<b>T.I. no.:</b> 2023-07 <b>Updated:</b> 15.03.2023	<b>Topic:</b> Wrong hose mounted, Steam boiler
--	--

## WRONG HOSE AT THE STEAM BOILER

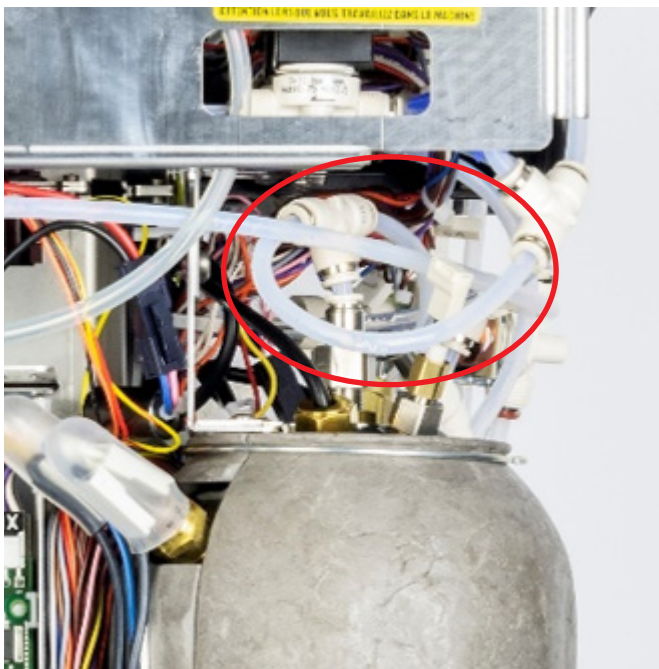
We would like to inform you about an assembly error that may affect all machines produced in the period CW40/2022 to CW 05/2023.

During the mentioned period, the machines were equipped with a too small hose diameter to the steam boiler. The result is a reduced steam output, which affects the quality (too low temperature) of the milk beverages.

We recommend exchanging hose 3/6 for hose 4/6 to achieve the desired temperature performance.

- > Item number: 067760 (4/6 PTFE)
- > Hose length: 180 mm
